| Project Title: | Hydrogen Energy Center Application for Certification Amendment |
| Document Title: | Project Refinements |

Re: Hydrogen Energy California Project (08-AFC-8A): Project Refinements

Amended Application for Certification for HYDROGEN ENERGY CALIFORNIA (08-AFC-8A) Kern County, California

REVISED FIGURE 2-47

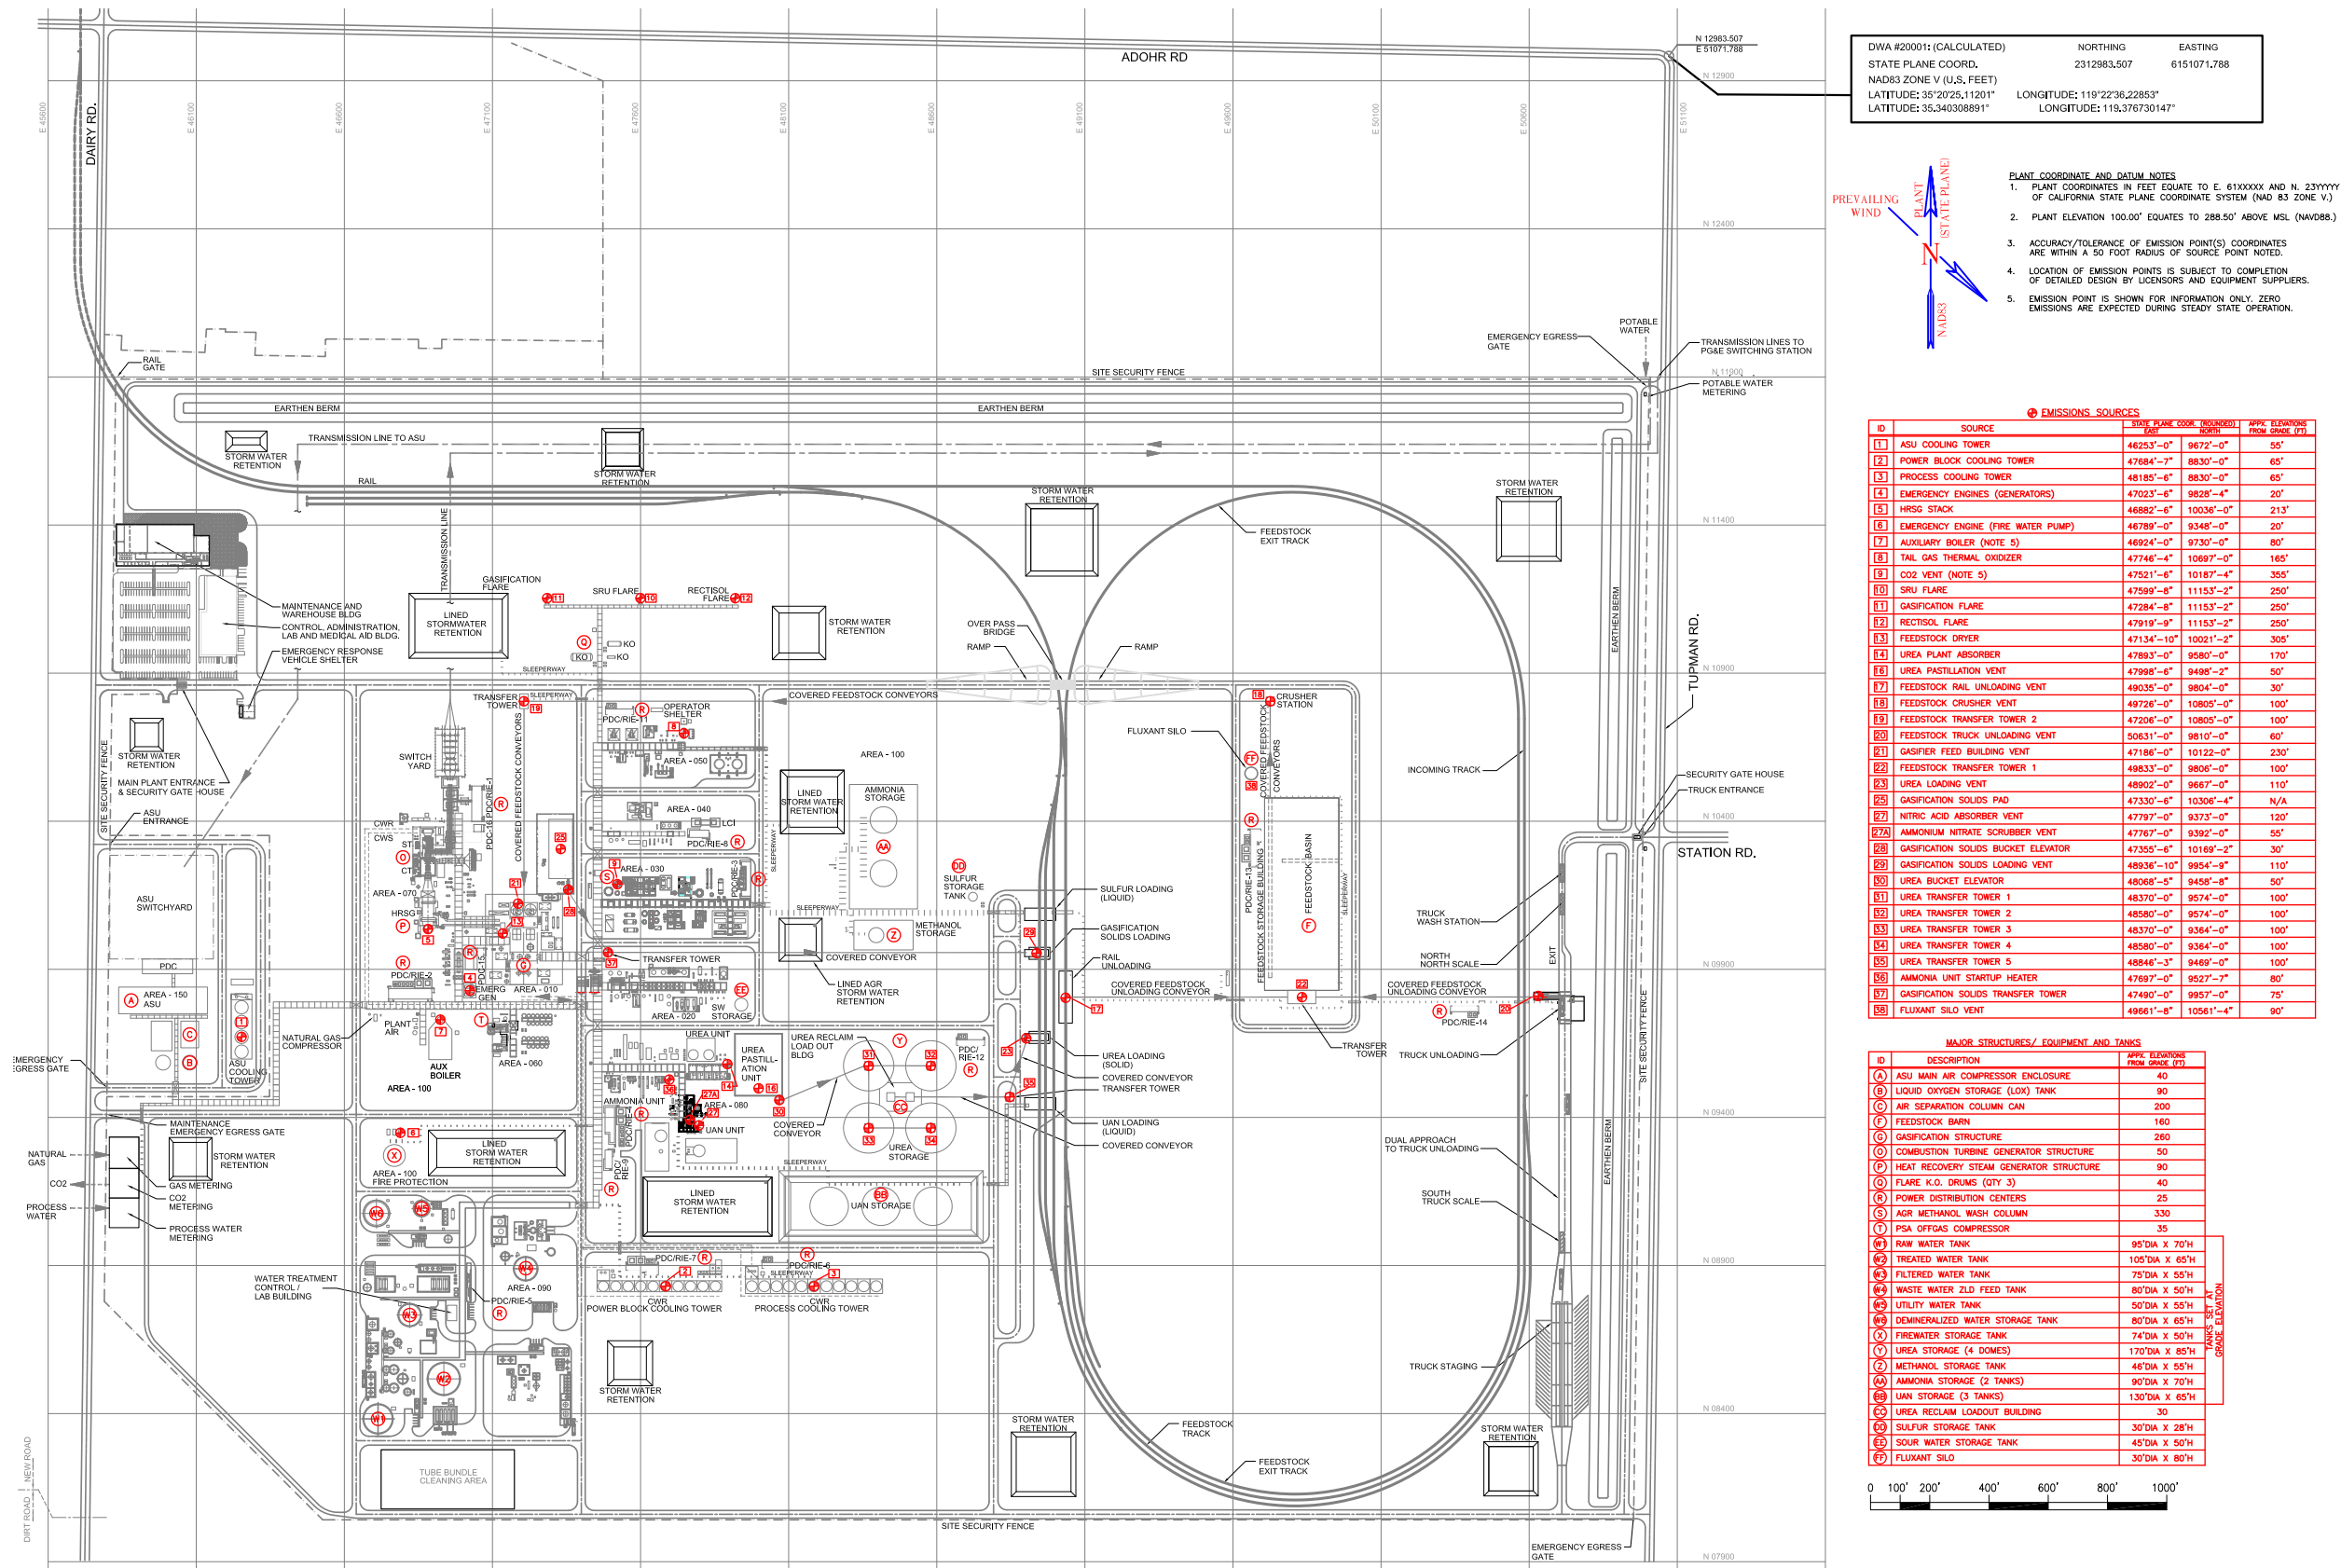
Major components located on the Project Site will remain essentially the same as described in the Amended AFC. The locations of some features have been adjusted, including the heat recovery steam generator (HRSG), feedstock dryer, cooling towers, flares, CO₂ vent, Manufacturing Complex features, material handling features, and emergency engines. Several buildings and tanks were moved slightly or have revised dimensions. A few stacks have different heights and parameters. These components are shown on Revised Figure 2-5, Preliminary Plot Plan, Revised Figure 2-6, Project Elevations, and Revised Figure 2-47 Preliminary Emission Sources Plot Plan.

An additional air emissions mitigation device—a benzene removal section—has been included in the Rectisol[®] unit to remove and return benzene back into the gasification oxidation zone for destruction. A small amount of residual benzene may partition into the CO₂ stream, where it would be sequestered. HECA has updated the emissions from the CO₂ vent to include the residual benzene. Due to the addition of the benzene removal section to the Rectisol[®] unit, the height of the methanol wash column has increased from 235 to 330 feet, and the CO₂ vent height has been increased from 260 to 355 feet.

The methanol AST is in the same location as the previous 300,000 gallon AST. The location of the methanol AST is shown on Revised Figure 2-5 and Revised Figure 2-47. A pump and an isolation valve are placed on the piping between the storage tank and the AGR unit, physically isolating the AST and AGR units.
